CITY OF ALBUQUERQUE

November 6, 2017

**Re: Floor and Decor
4930 Pan America
Traffic Circulation Layout
Architect's Stamp 10-11-17 (F17D032)**

Sheet:
A5101

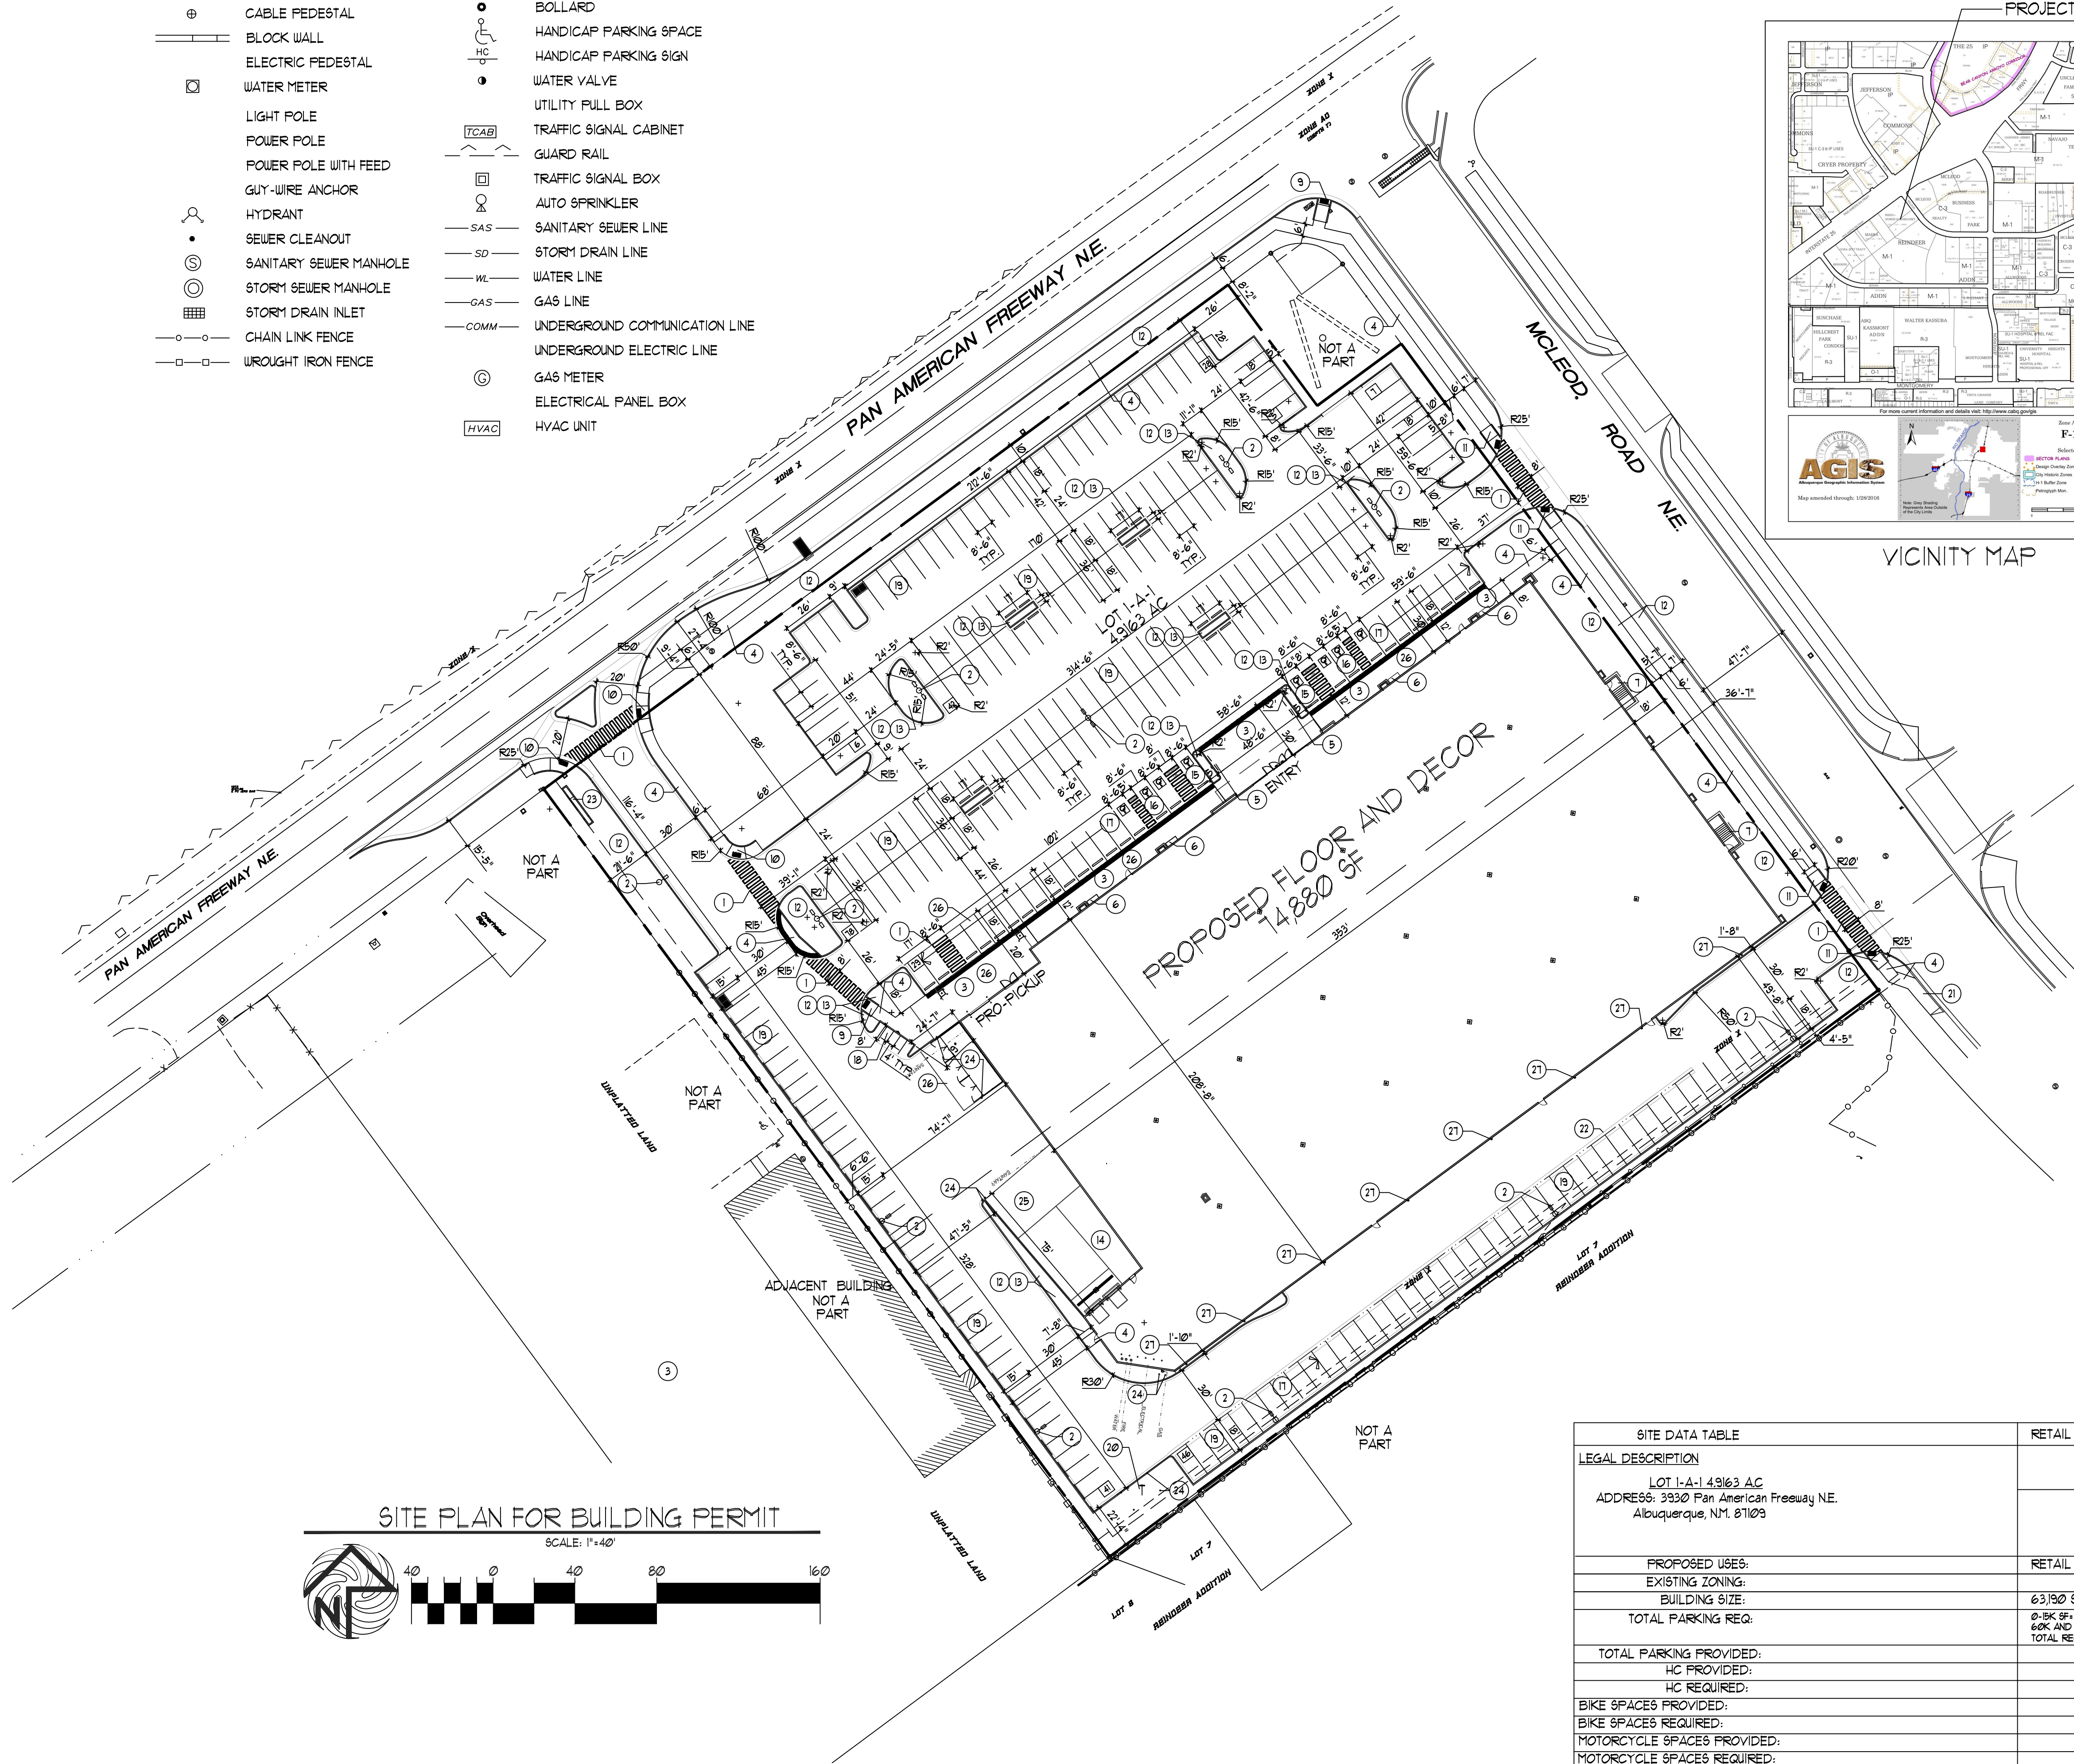
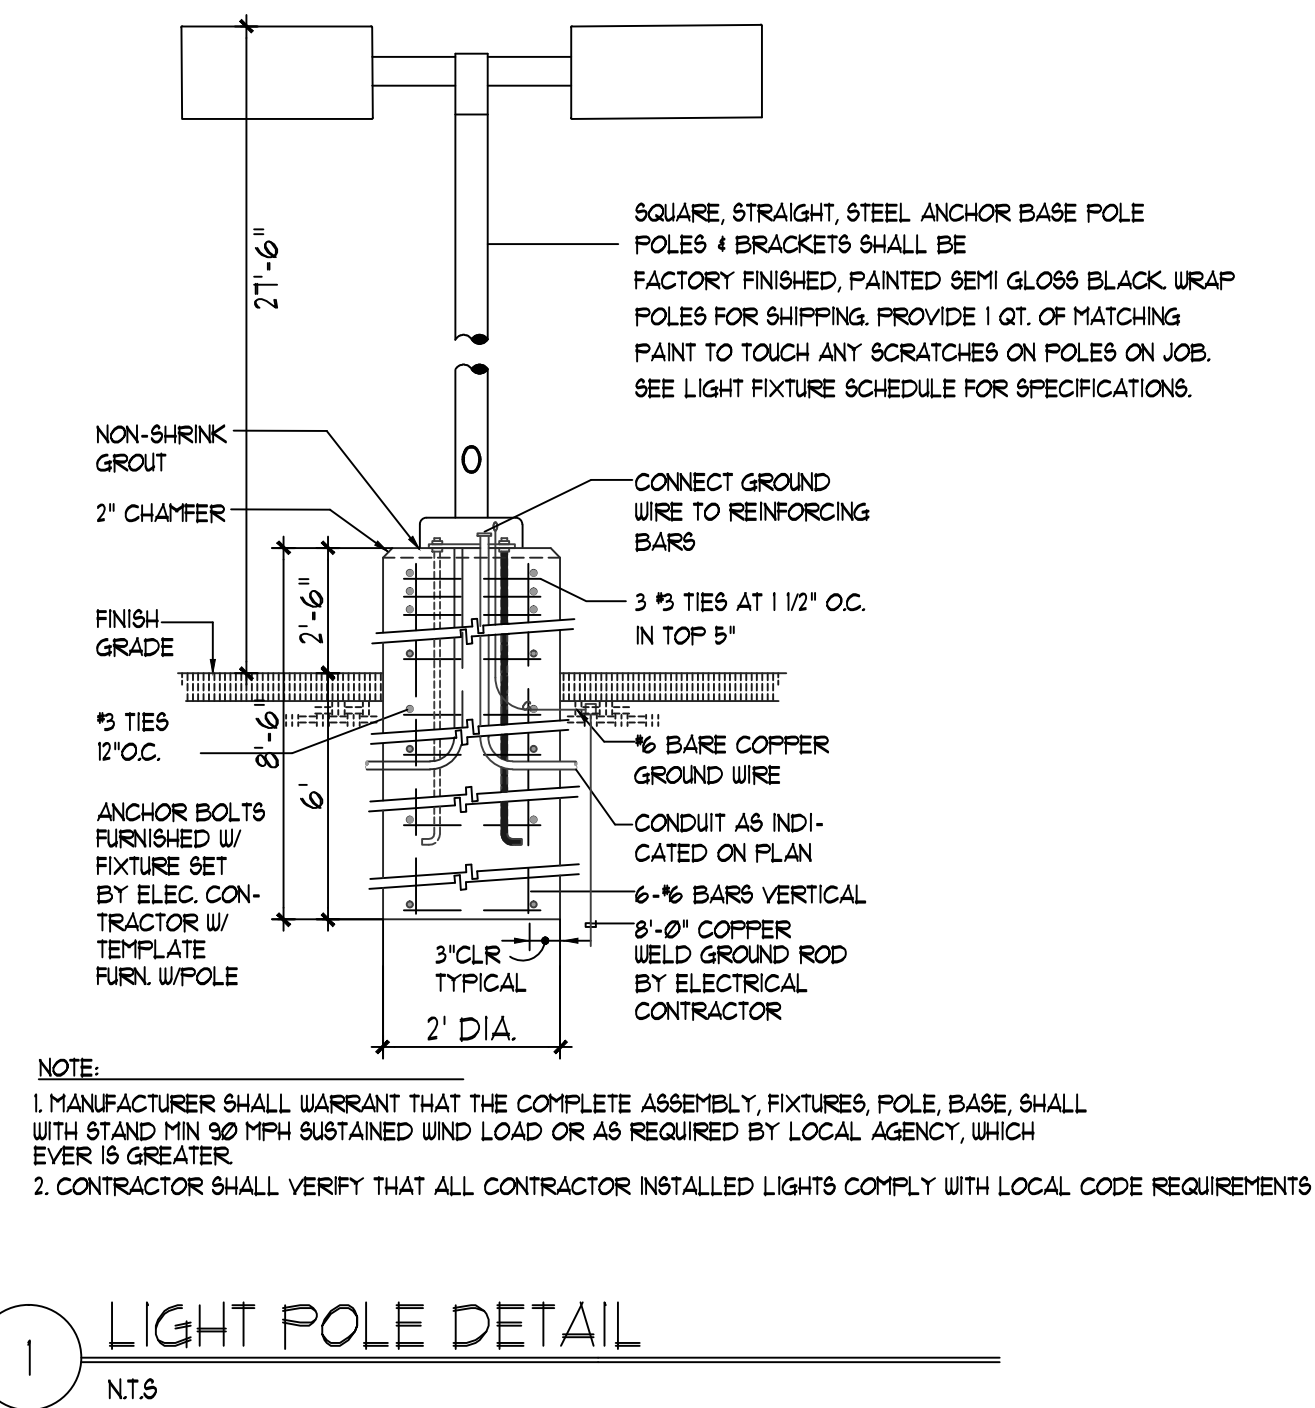
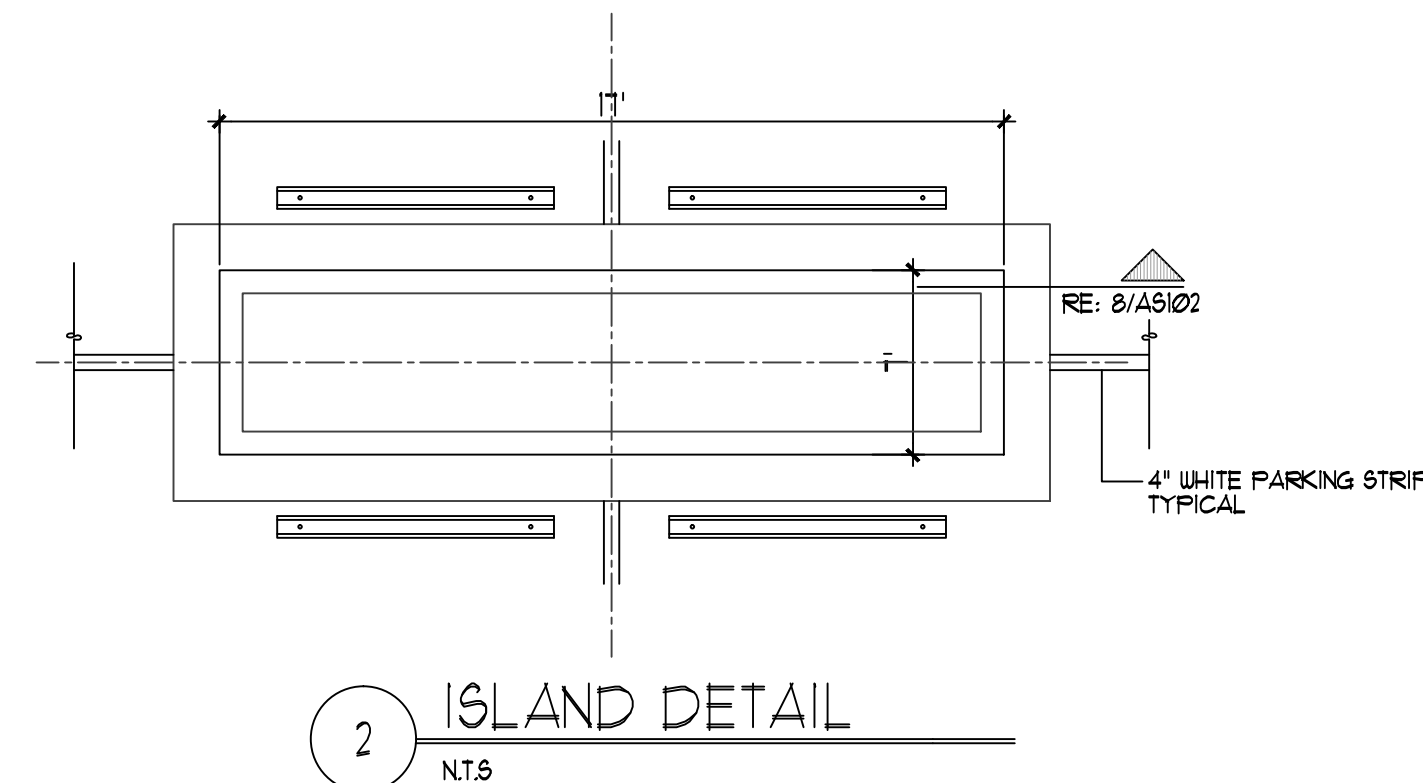
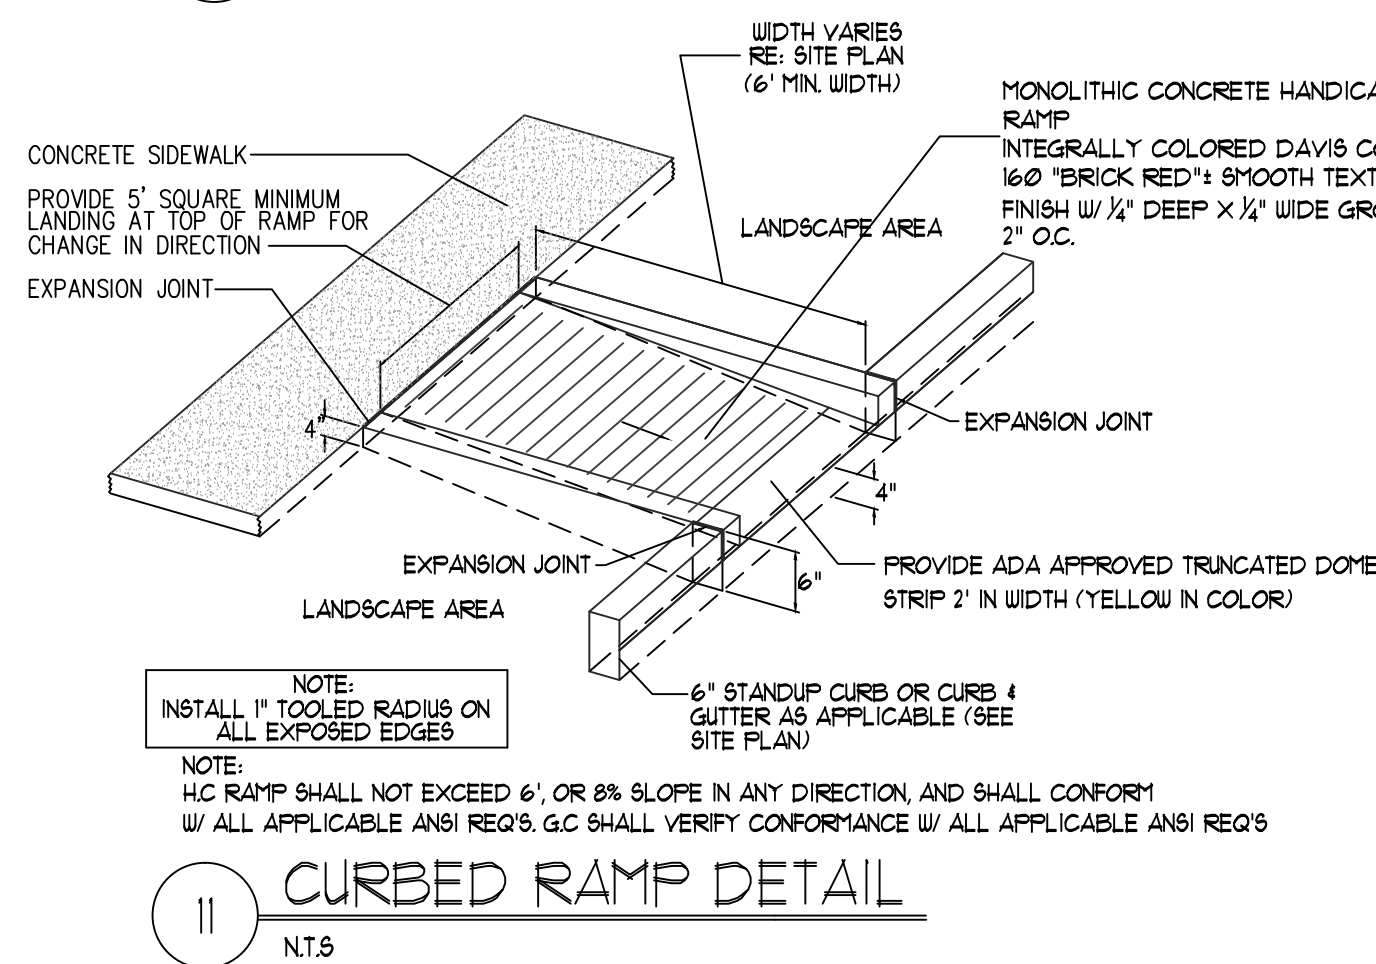
1. All sidewalks along streets should be placed at the property line.
2. Label the compact parking spaces by placing the words "**COMPACT**" on the pavement of each space.
